CAMANO CHAPEL

867 SW CAMANO DRIVE, CAMANO ISLAND WA.

PHASE 1,

REV.	AUGUST 11, 2008 PERMIT SUBMITTAL
REV.	AUGUST 21, 2008 PERMIT CORRECTION
REV.	
REV.

SECOND FLOOR EXIT PLAN
1/8" = 1'-0"

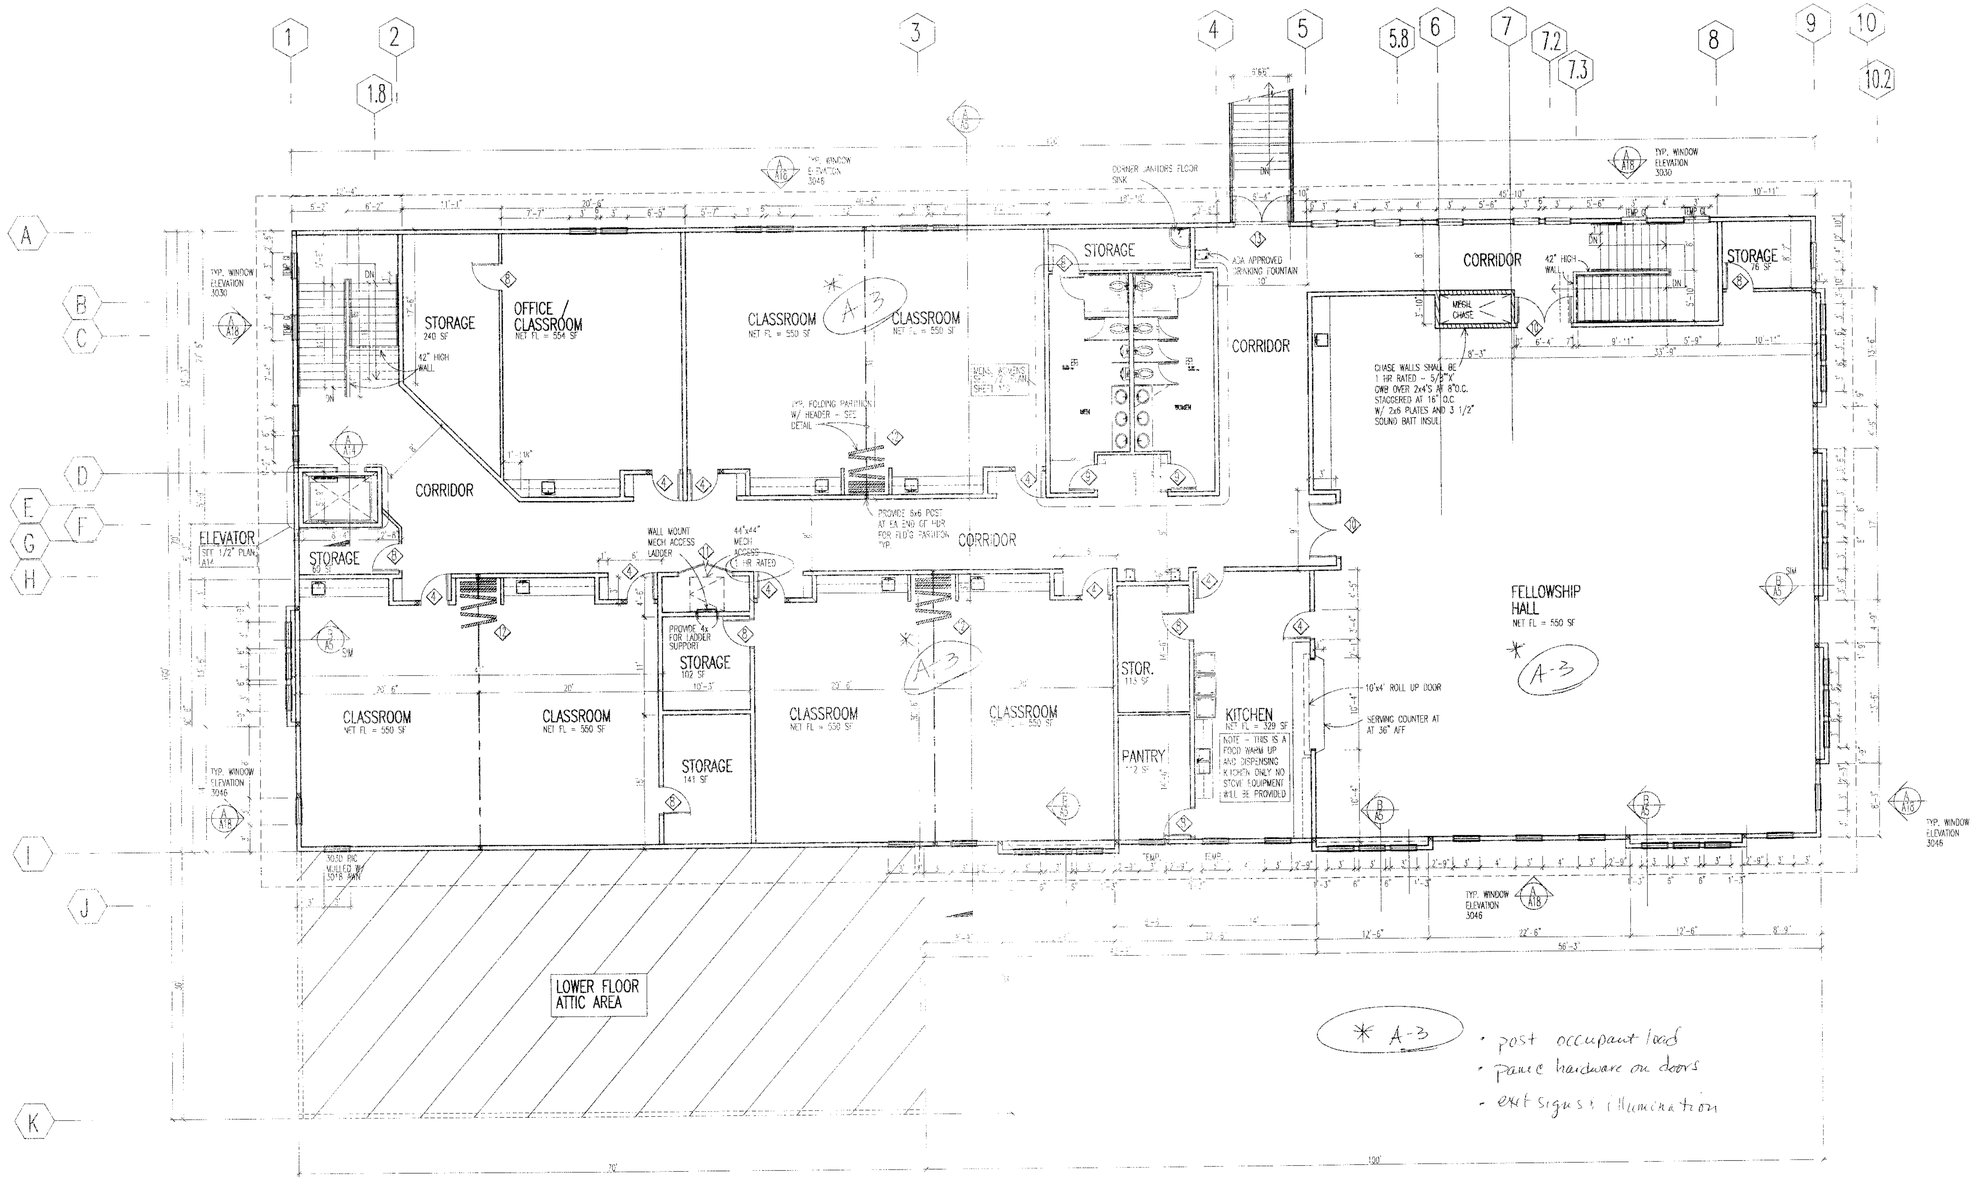
* A-3

- post occupant load
- panic hardware on doors
- exit signs illumination
